PLAN OF PROPOSED IMPROVEMENT

NINTH ADDITION TO BLACKHAWK SUBDIVISION - PLAT AND REZONE

CITY PROJECT NO. 11943

SHEET NO.
X-9

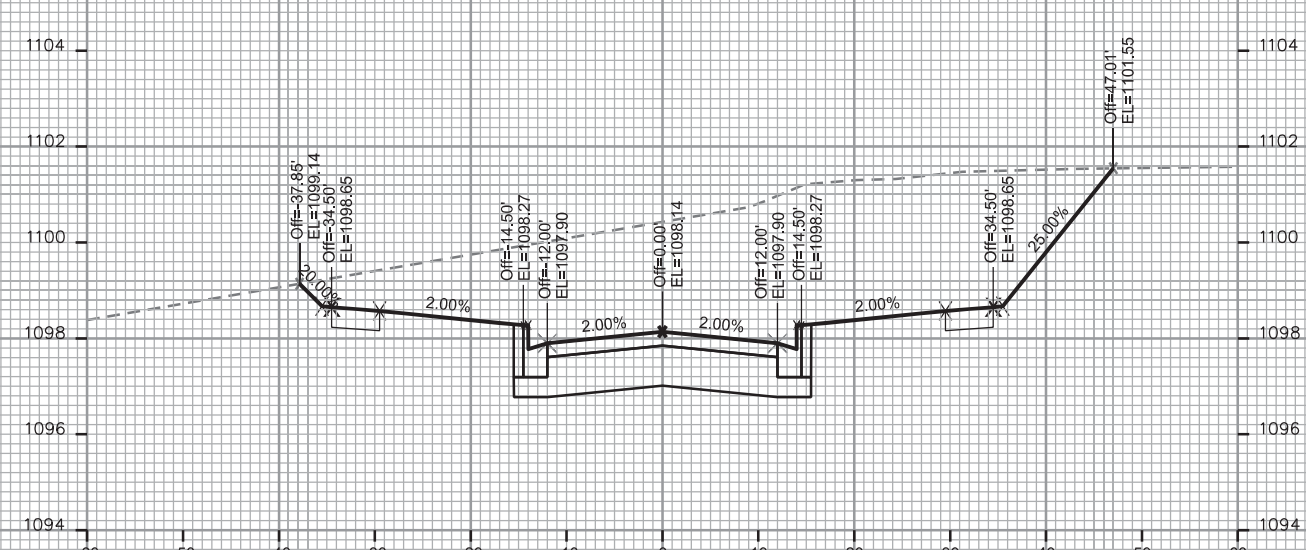
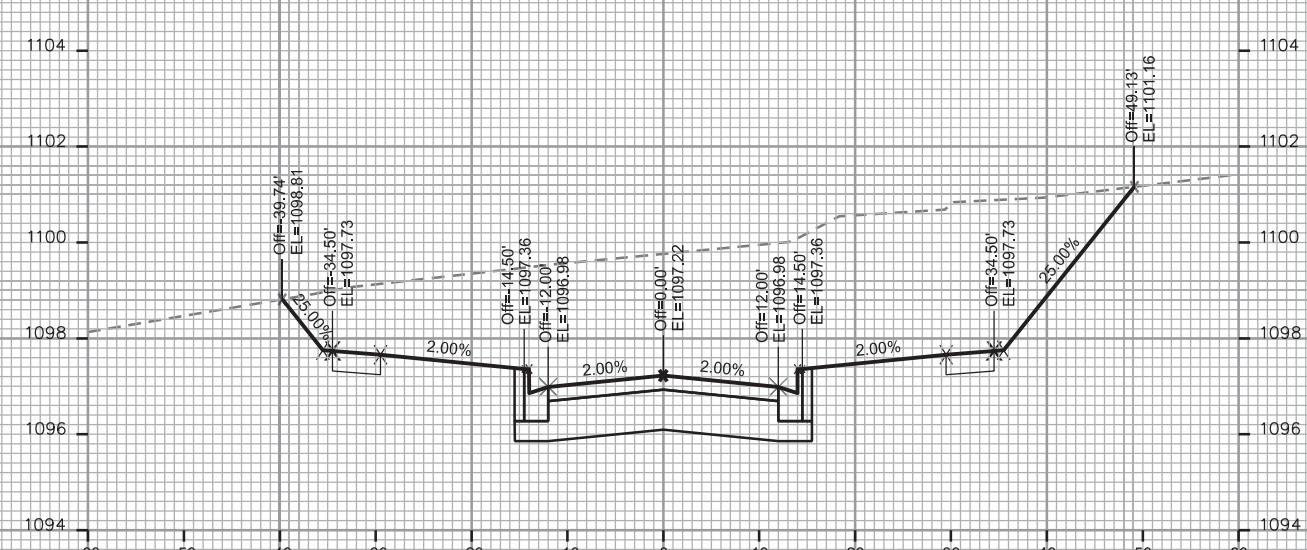
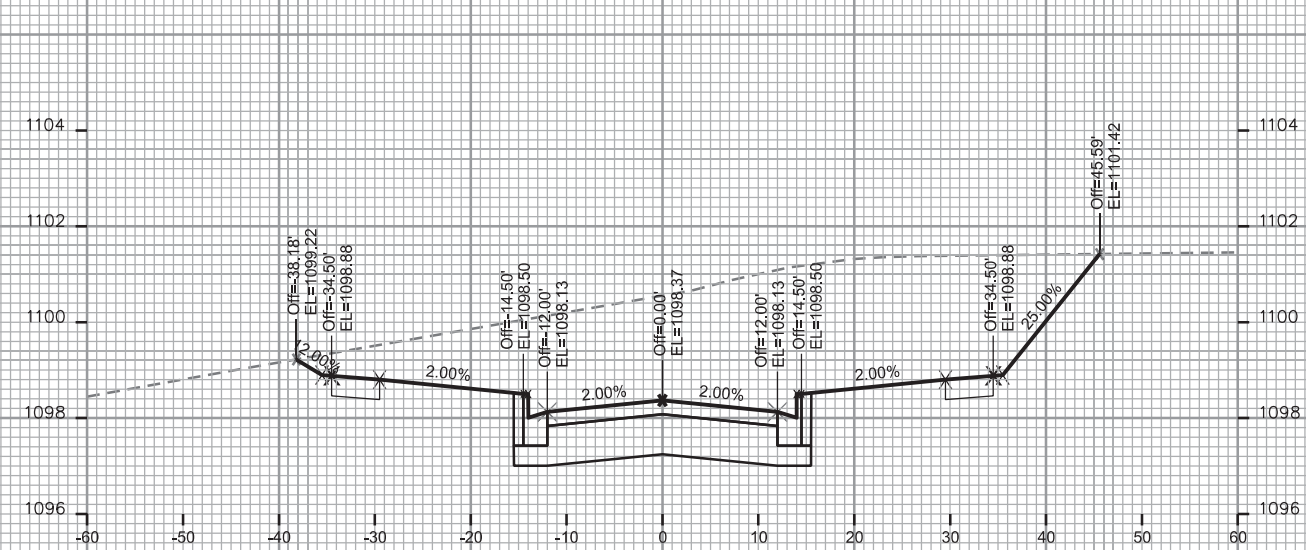
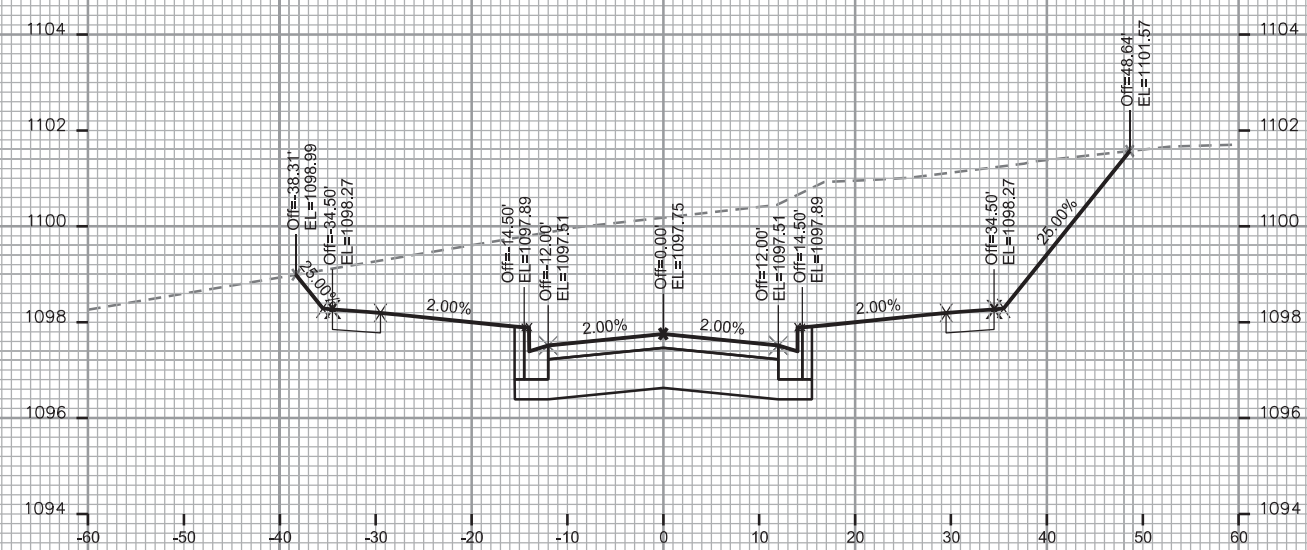
Revised 11-15-2018 AJZ
-revise to reflect correct
terrace width profile updates

SHEET NO.
X-11

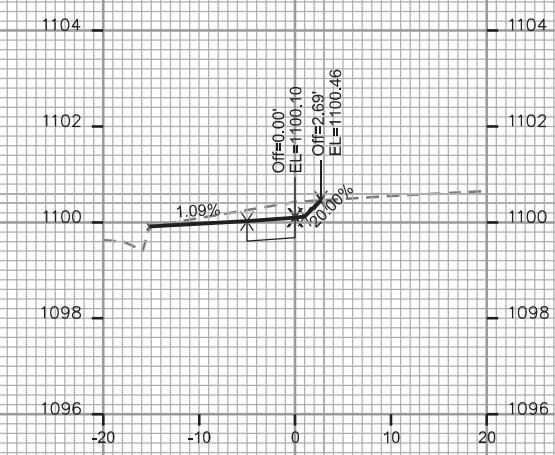
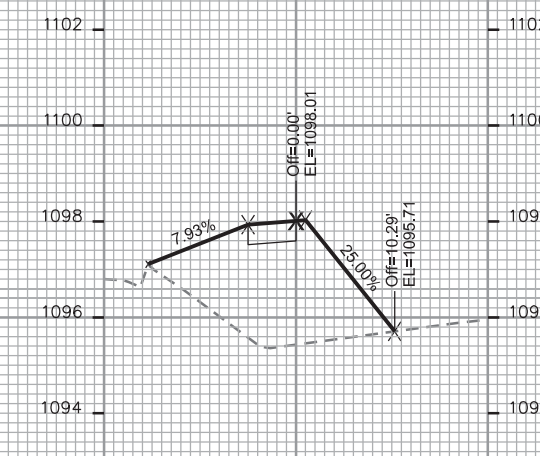
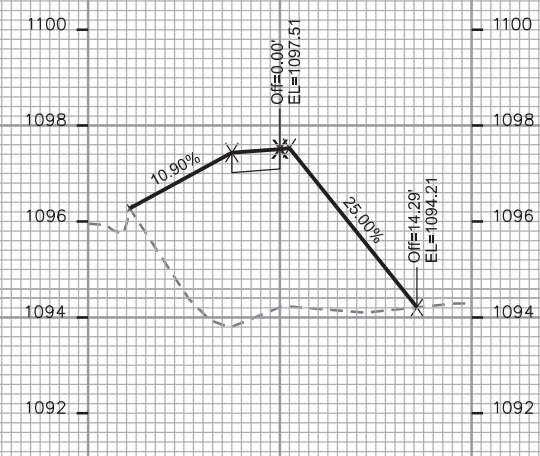
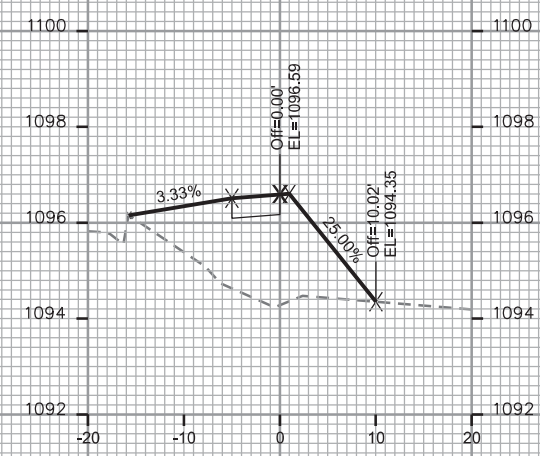
Revised 11-15-2018 AJZ
-revise to reflect sidewalk
elevation changes
